Memorandum

FROM : Hilbert W. Crocker, Inspection Specialist (Criticality)
Region III, Division of Compliance, Chicago

SUBJECT: PART 70 INSPECTION, WESTINGHOUSE ELECTRIC CORPORATION, PITTSBURGH,
PENNSYLVANIA - LICENSE NO. SNM-338 (DOCKET NO. 70-337)
INSPECTION DATE: APRIL 29-30, 1965

Figure 1
Vault 4-a
Scale: 1" = 4'-0"
6-8-62

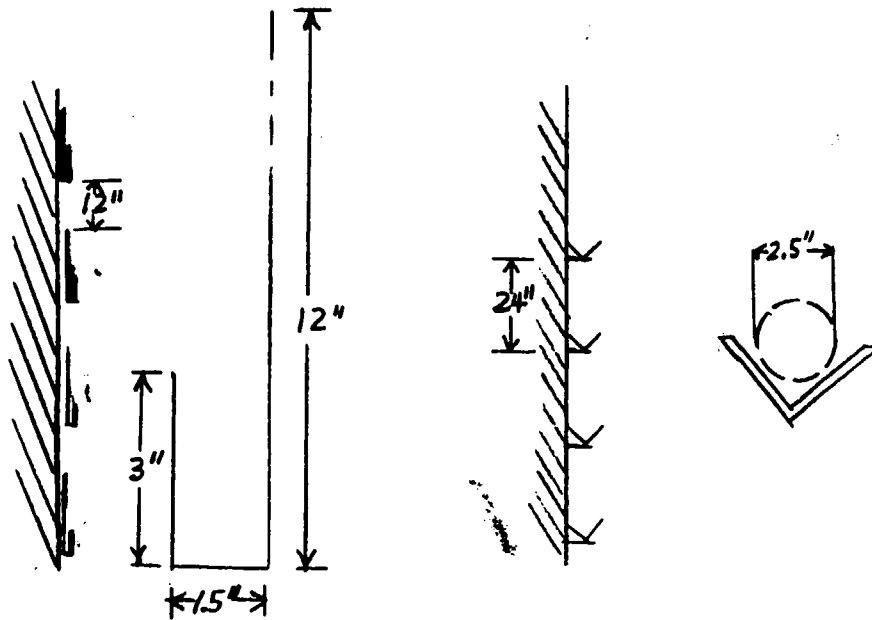
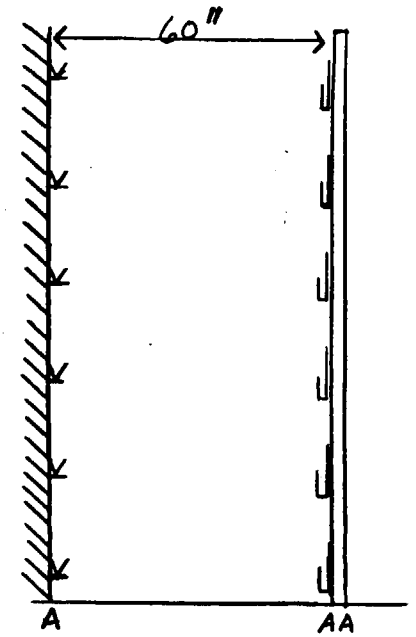
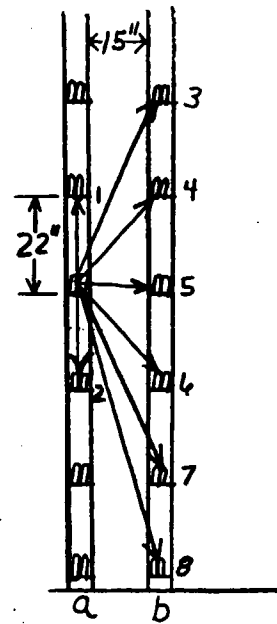
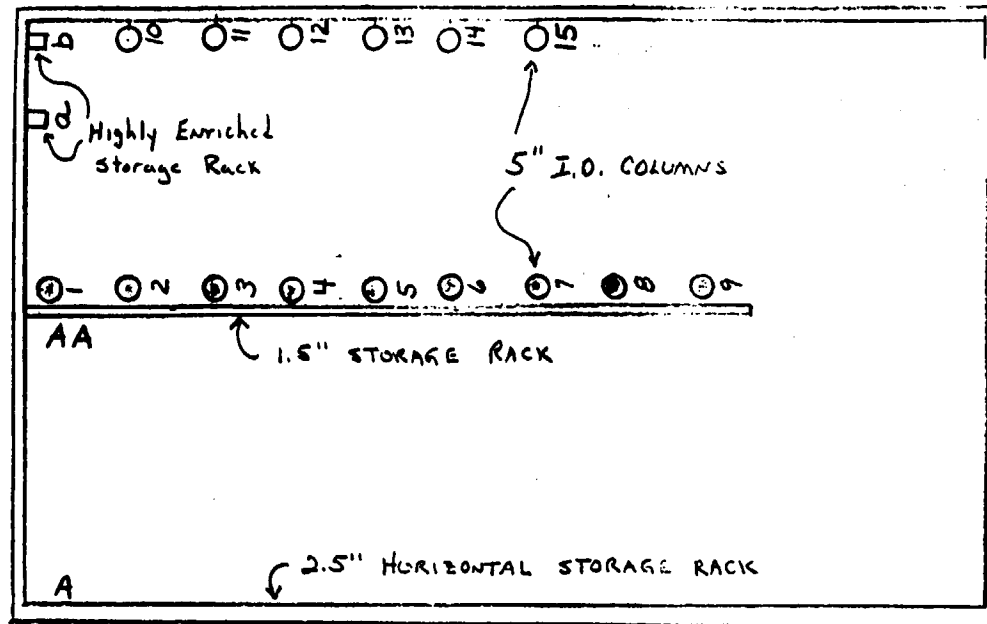
Comment 1. Please submit solid angle calculations for Vault 4-a.

The following solid angle calculations for deriving a fast neutron surface density limit will be used to show the array in Vault 4-a:

Mass control is used in the highly enriched storage rack, Figure (2), (3), and (4). Each part is 4" x 6" x 6". A 6-inch diameter sphere is assumed for interaction calculations (See Fig. 1).

Figure 2
A.T.R. Movecarts
Scale 1"=4'-0"

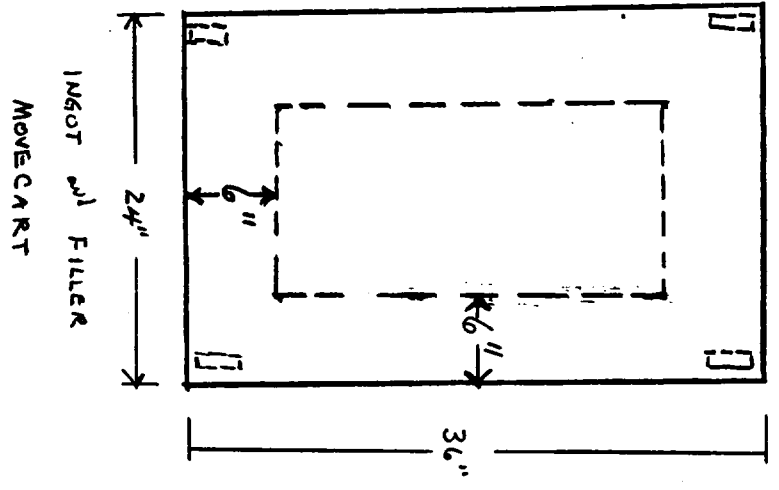
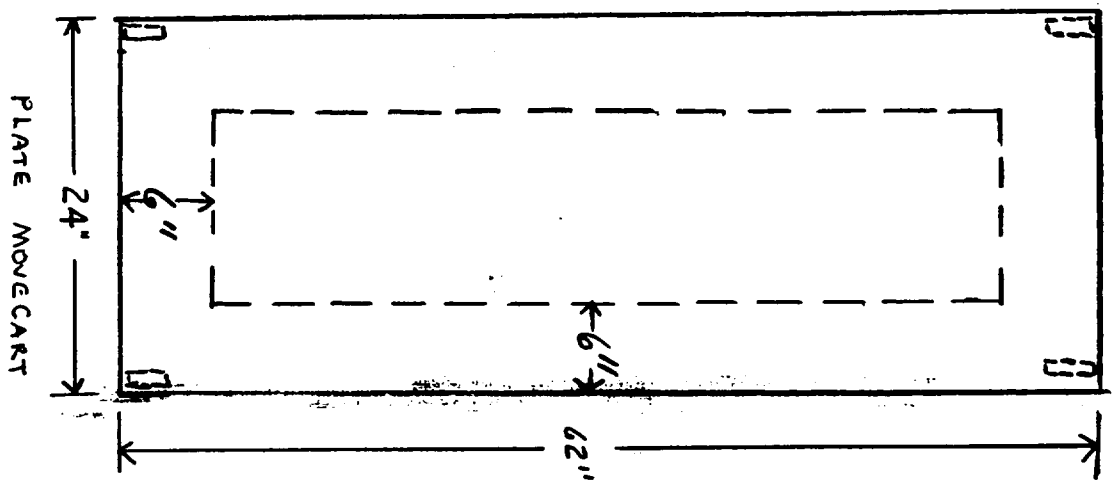
Comment 2. Please confirm that mass control will be used on all ingot, filler and plate movecarts instead of the planar concept.

Mass control is used to control the loading limit on the movecarts. The 27 weight percent uranium-73 weight percent aluminum alloy has a fractional density of 0.05. The allowance factor on the mass limit is 5.9 (TID-7016, Fig. 5, p. 12). The individual movecart systems are discussed below:

Our concern arose from the situation diagramed in Figure 2.

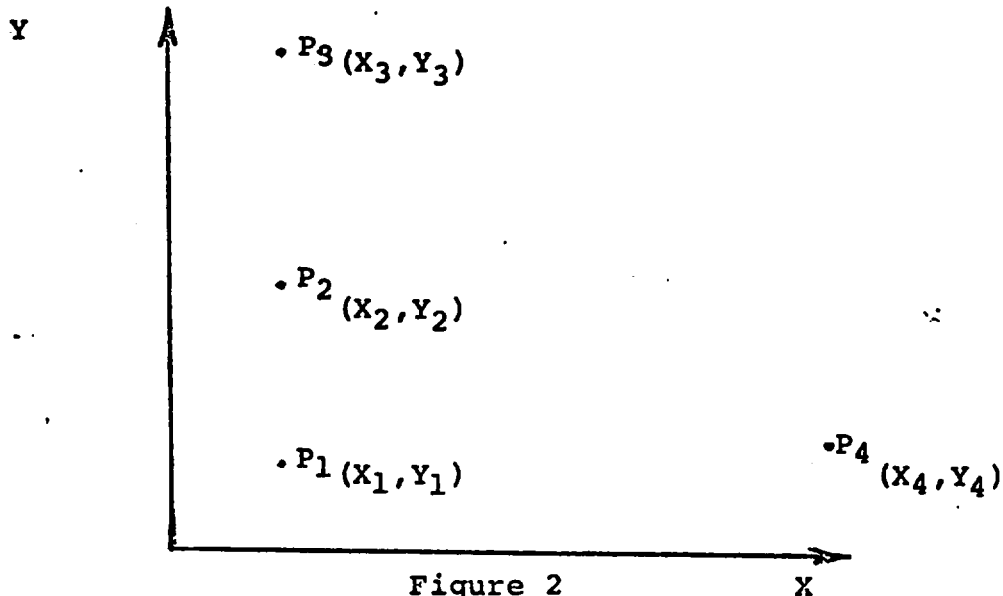
Examination of this figure demonstrates that since P_1 , P_2 and P_3 are in a line, $X_1 = X_2 = X_3$ and the quantities $X_2 - X_1$ and $X_3 - X_2$ are equal to zero. Therefore, no exclusion area would be permitted. A statement that permits such a condition is obviously erroneous. Similarly, $Y_4 - Y_1$, is very small, so that although the points are widely separated, they would drastically limit the exclusion area available around each point. This also is unrealistic.

Westinghouse has modified the proposed license condition to provide for these conditions, which are particularly prevalent in the PFDL where operations are carried out in glove box lines.

Figure 3

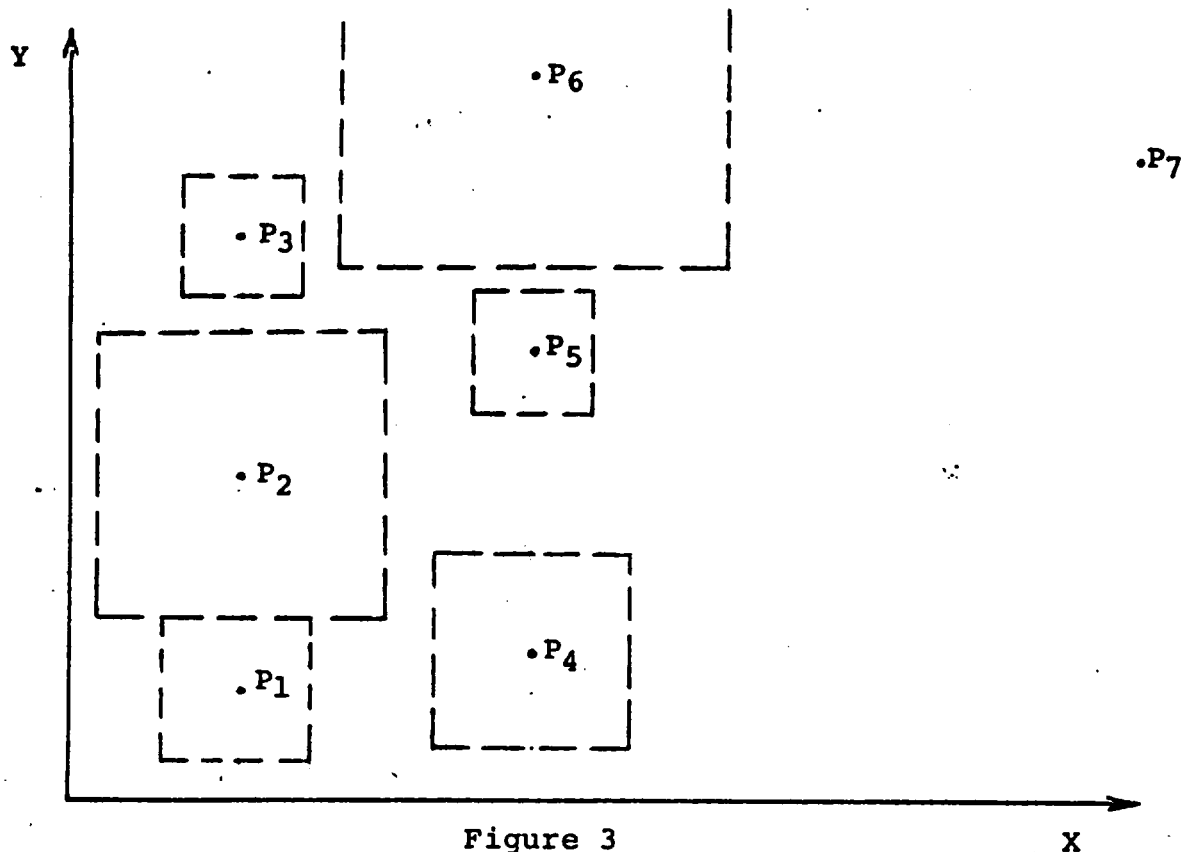
Assuming an arrangement similar to that in Figure 2, Westinghouse would provide exclusion as shown in Figure 3.

Thus Line 1, containing P₁, P₂ and P₃ in a linear array and Line 2, containing P₄, P₅ and P₆ in a separate linear array would be spaced based on center-to-center distances within the individual lines. The only requirement would be assurance that none of the areas "assigned" to one line overlaps an area reserved for the other. P₇ would be considered separately, and would not be evaluated relative to either P₃ or P₆.

SCHEMATIC PLAN OF ARD PLUTONIUM OXIDE LABORATORY

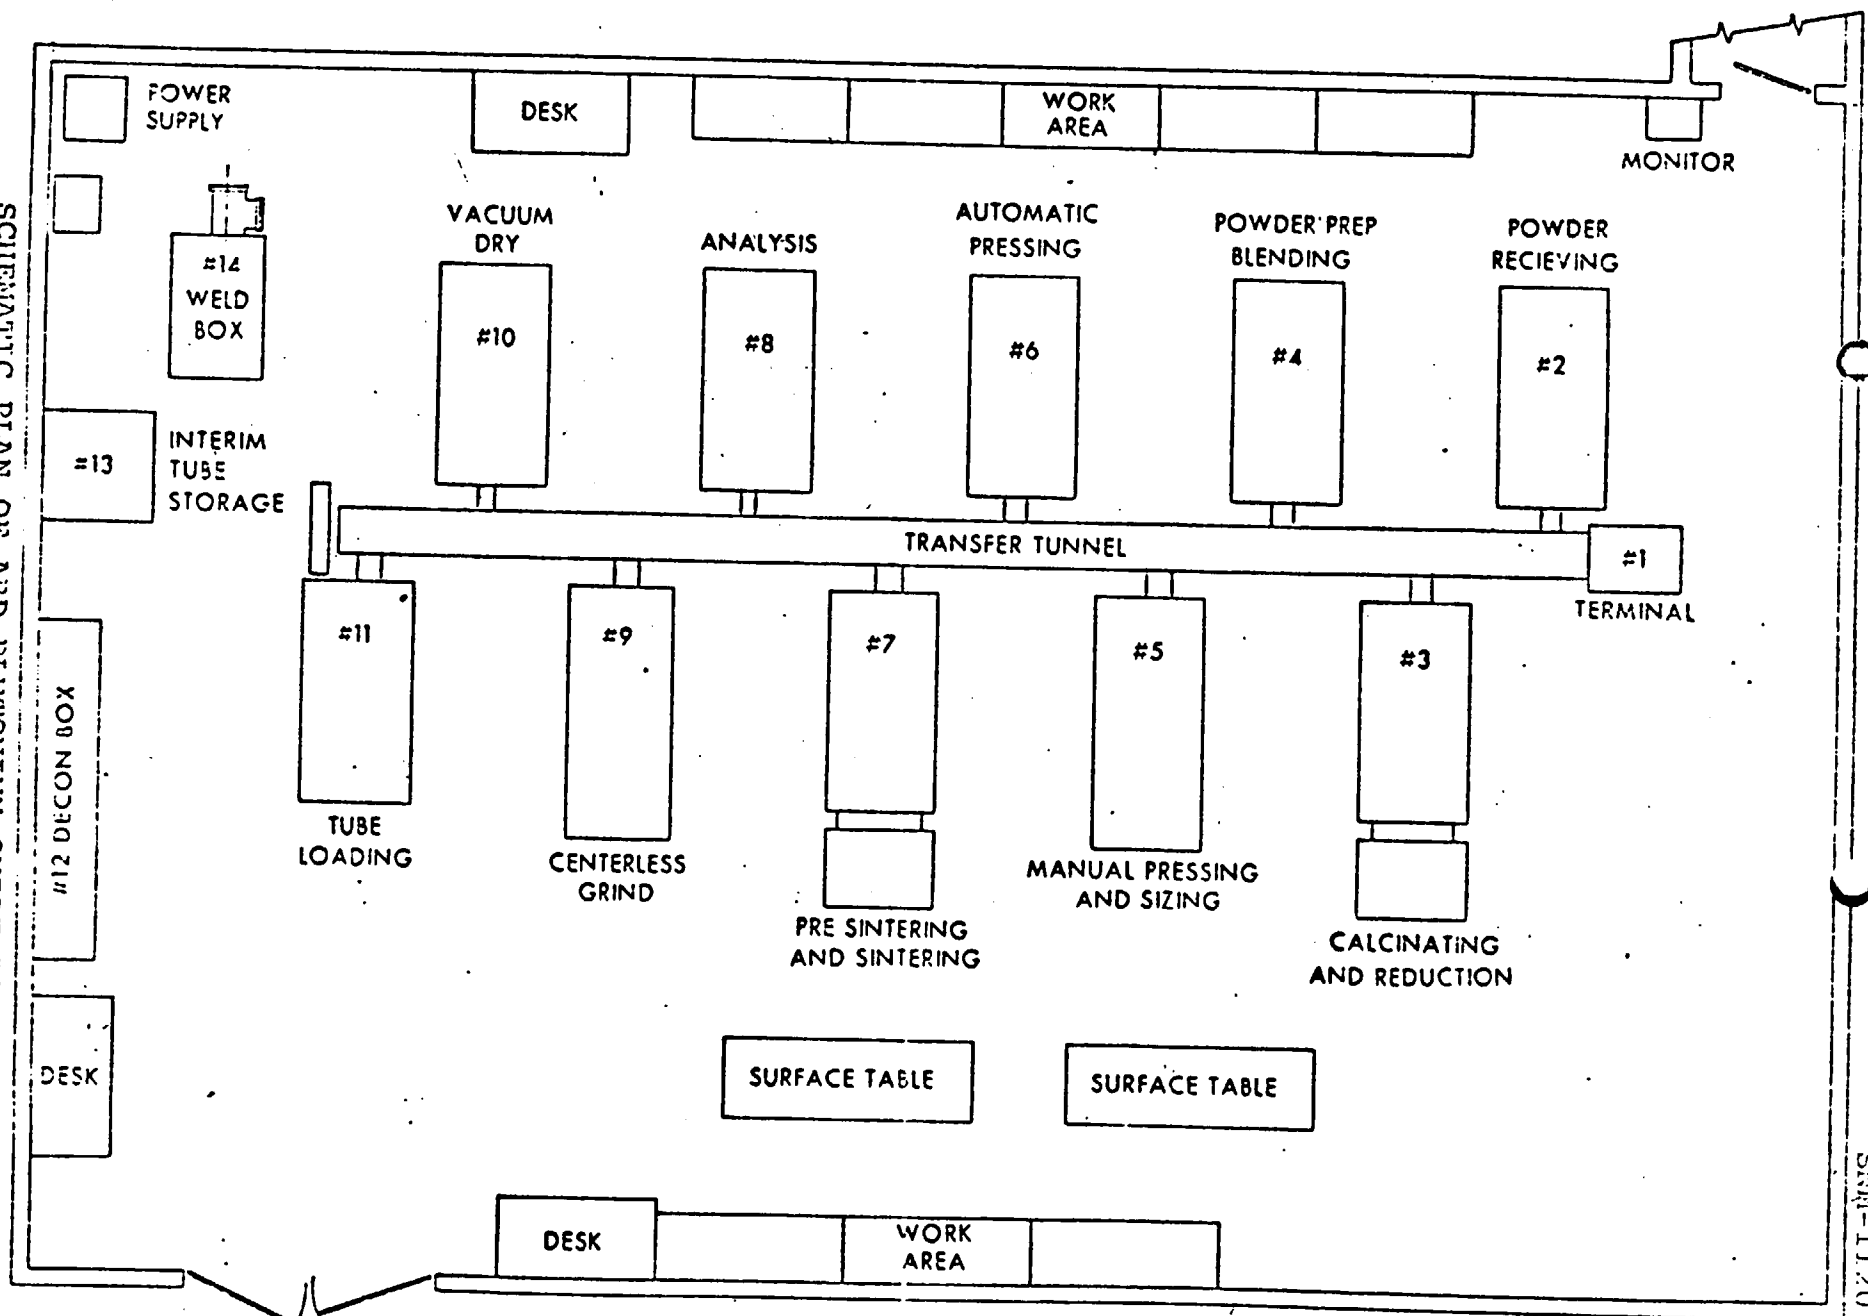
A practical application of this approach is demonstrated in the attached Figure 9.2.2 taken from the application. Obviously, the spacing considerations for Boxes #2, #4, #6, #8 and #10 should not be restricted because Boxes #3, #5, #7 and #9 are spaced directly in the gaps between them, when the odd-numbered boxes lie on the other side of the transfer tunnel.
